FIELD CHANGE ORDER

Reference No. : 00 135 015
Date : March 2000
Product Group : 742

OPTIMUS 50 / 65 / 80 RAD - R/F - C

Error combination 02WK + 02HG + 02HH + 00XO

XRGSCOPE >> Faultfind >> Logging Table >> Error Log >> Error Log Index

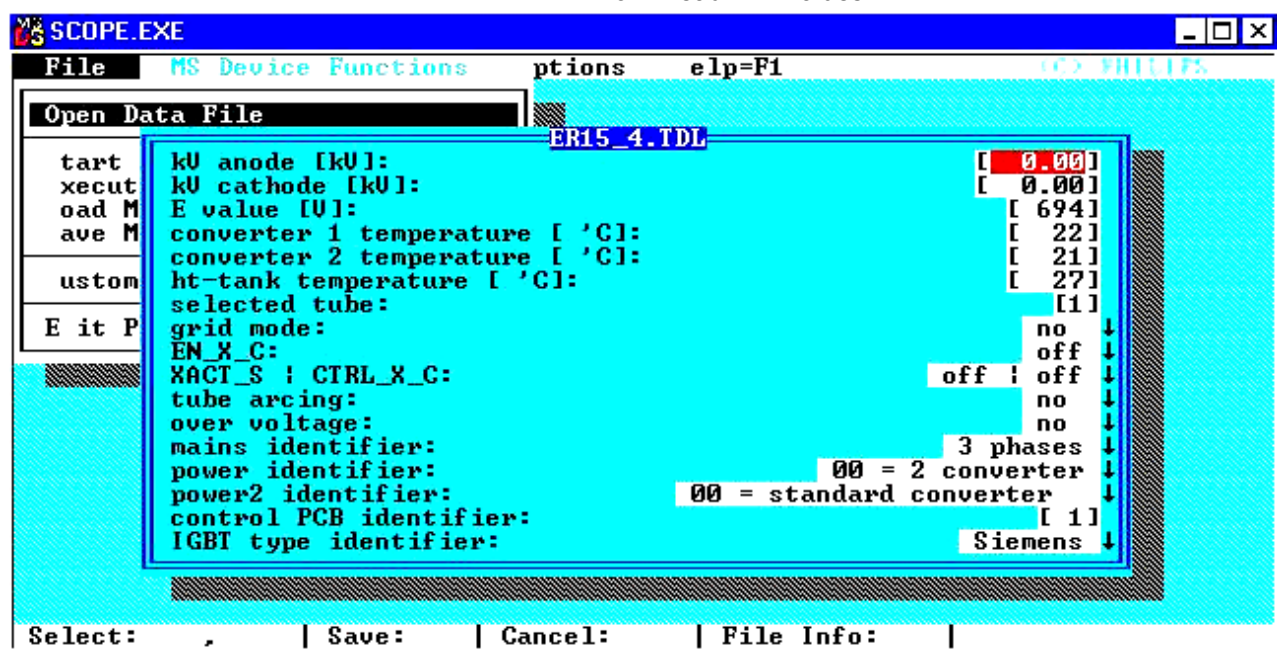
In case of a relay malfunction there will be no kV with exposure command. Error codes 02WK, 02HG, 02HH and 00XO might appear in different combinations, see following XRGSCOPE screen:

Ch 1 = EN_X/ at the generator backpanel test point EZX82 (+15VDC standby) against ground EZX87
 Ch 2 = EN_X_C/ at the generator backpanel test point EZX76 (+5VDC standby) against ground EZX5/6
 Trigger: Ch1 negative slope

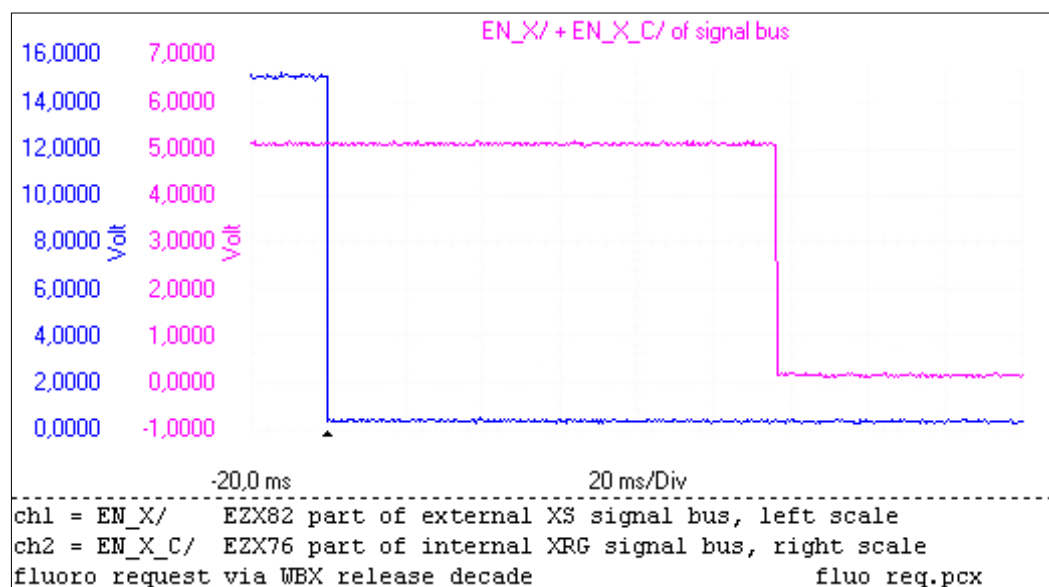
The contact behavior should be monitored with an oscilloscope to check that the EN_X_C/ is present all the times EN_X/ command was given.

Fluoroscopy request via release decade adaptation unit WB

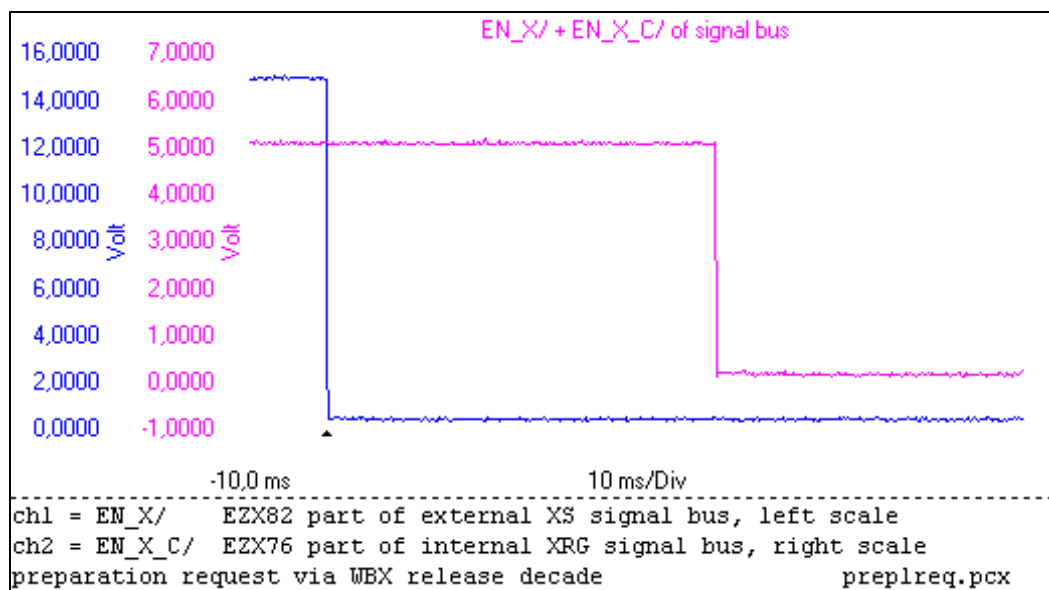
The signal behavior should be identical to the following oscilloscope screenshots:
